Our Case Number: ABP-317742-23

Re: BusConnects Bray to City Centre Core Bus Corridor Scheme
Bray to Dublin City Centre.

**Bray to City Centre BusConnects Scheme
(ABP Reg. Ref. HA27.317742)**

Client:	Sir Marc Cochrane
Project Title:	BusConnects Bray to City Centre Route
Document Title:	BusConnects Submission – Woodbrook Estate
Document/Job	JSA 19089 Ref 10102023 DV4

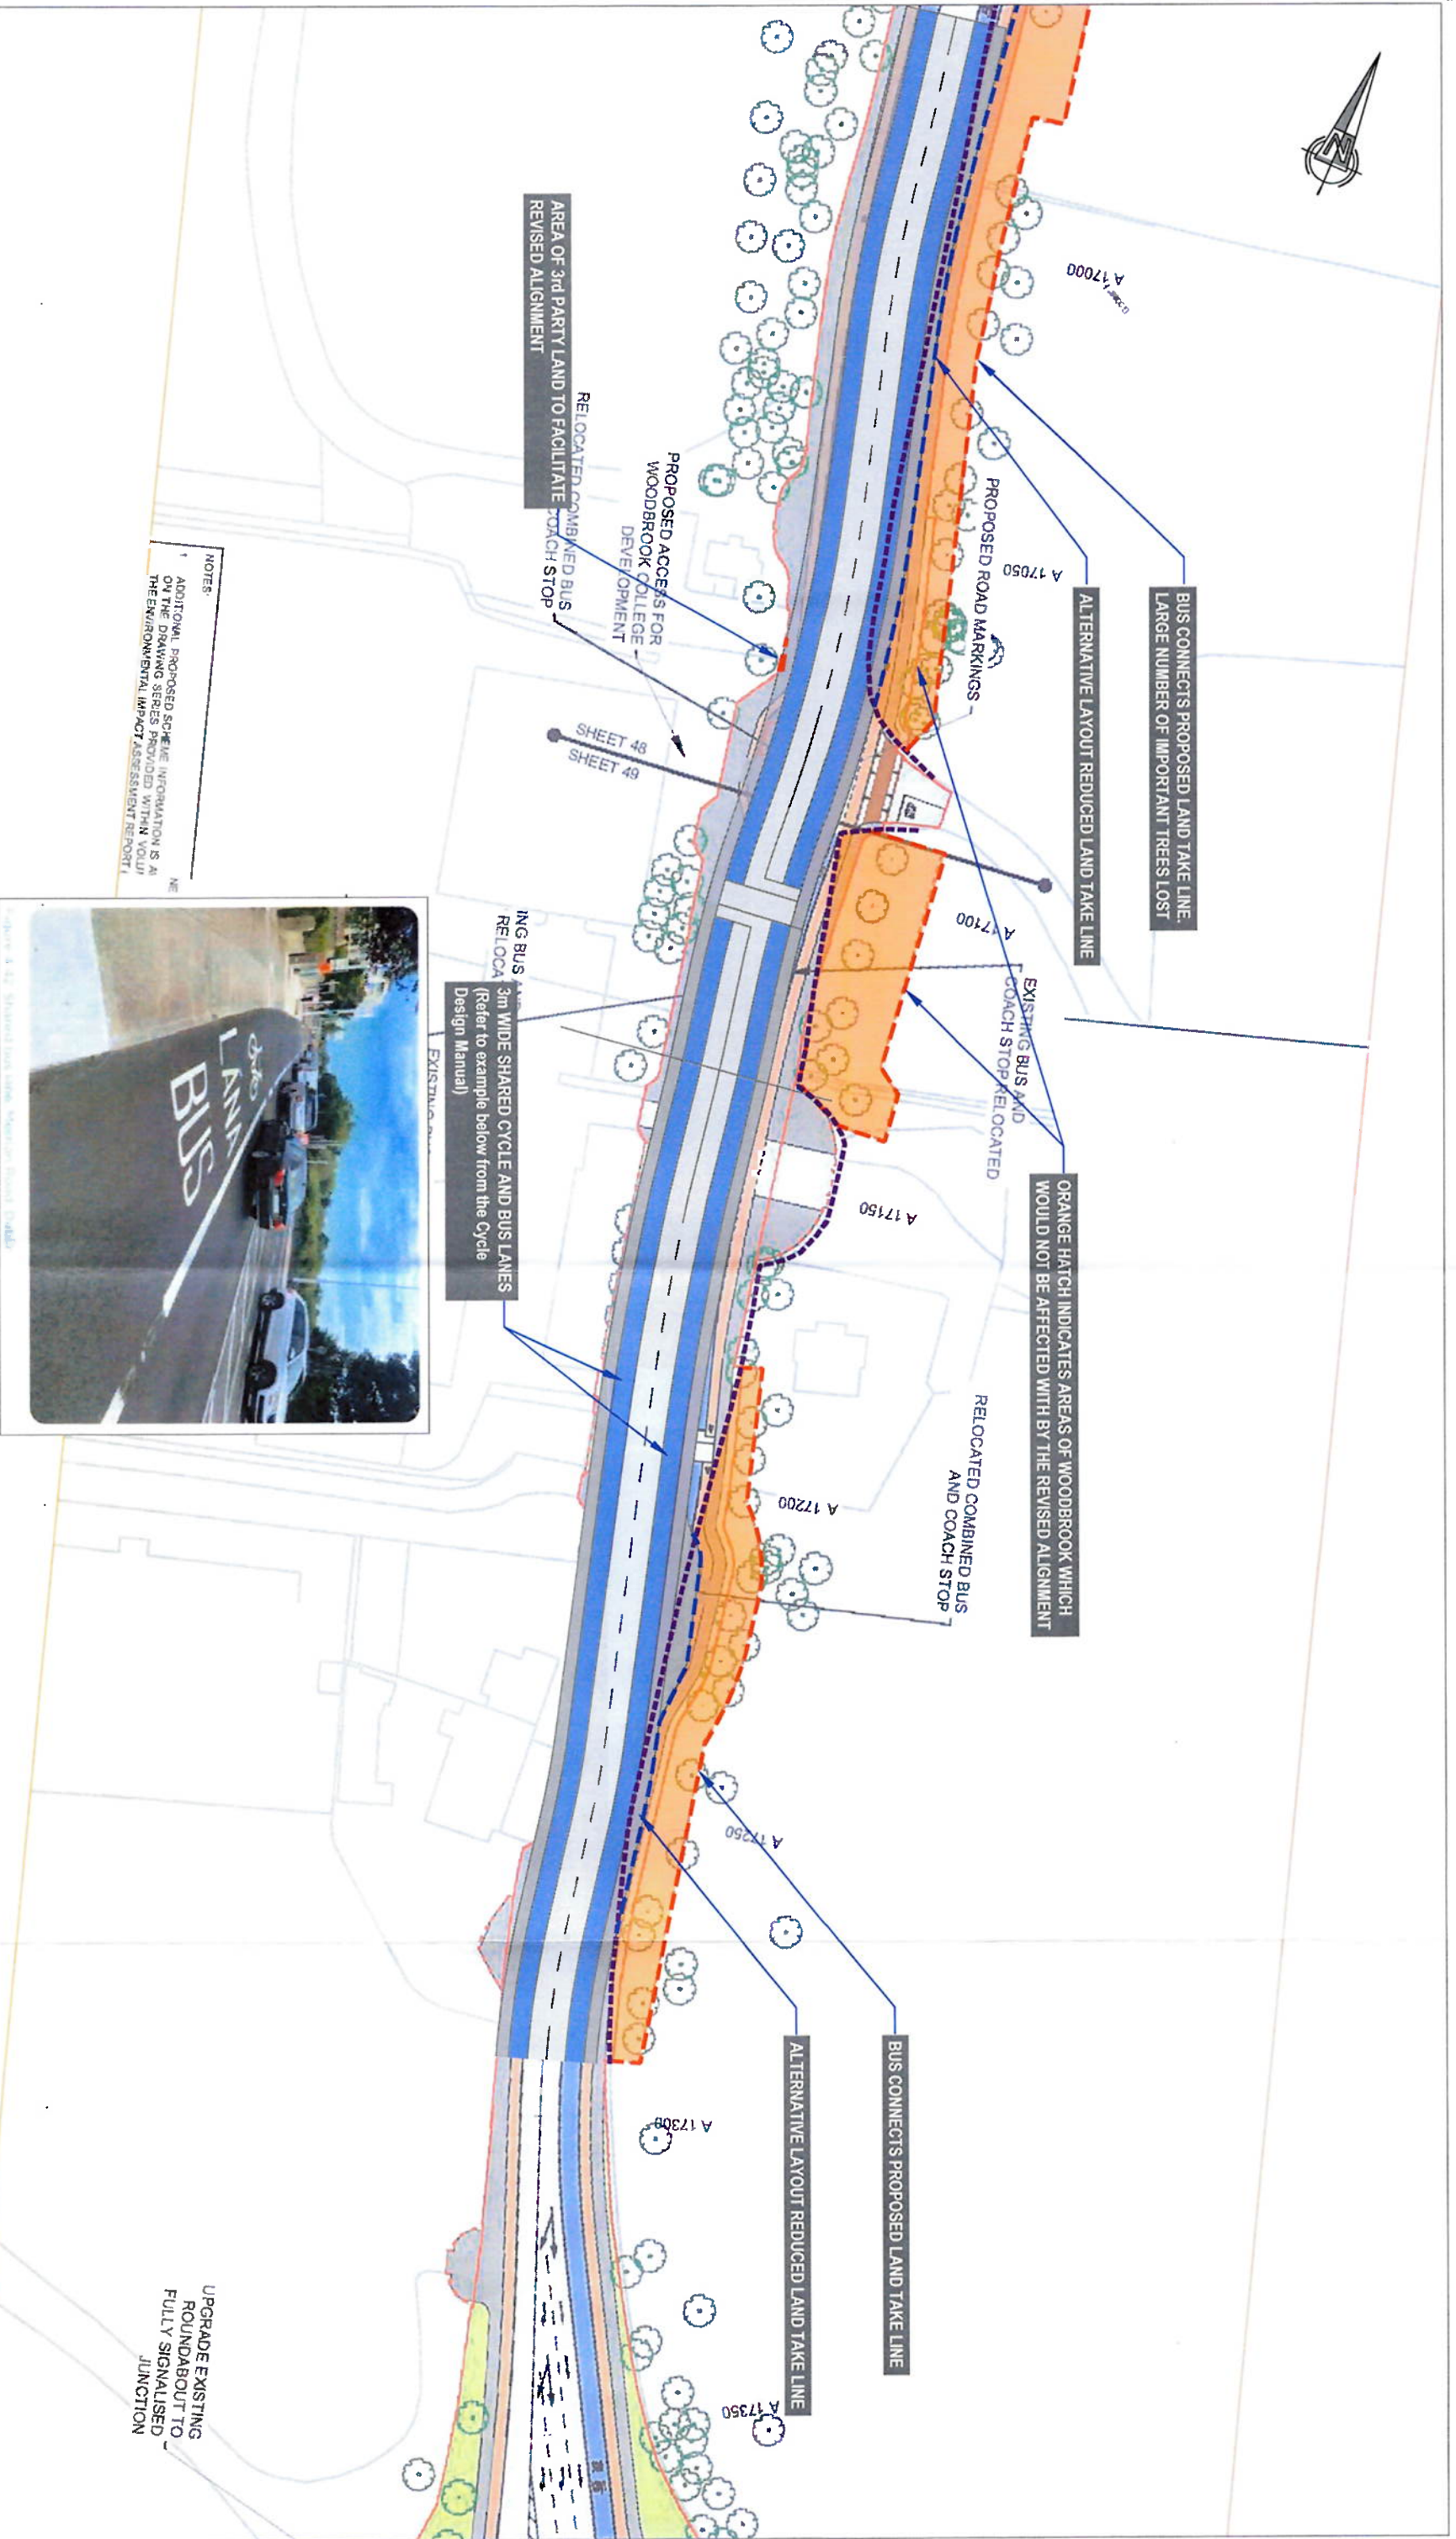
We have highlighted and enclosed an alternative layout as shown on **NRB-SK-23-01** which significantly reduces the impact on the property and which we believe will provide a safe, acceptable route for all users.

As previously proposed, we believe that the appropriate and far less damaging / contentious option for the Bray / City Centre section of Core Corridor 13 here would be to utilise a shared cycle & bus lane on both sides at this area, **similar to other sections of the Planned route e.g., in Donnybrook**. Unlike the offline cycle lane option proposed at Shankill, which is less direct and longer and therefore less attractive to cyclists, this provides a direct route to cyclists while reducing the impact on Woodbrook Estate.

This could be introduced with the detail fully in accordance with National Guidance as set out in The Cycle Design Manual and remaining consistent with other sections of the route.
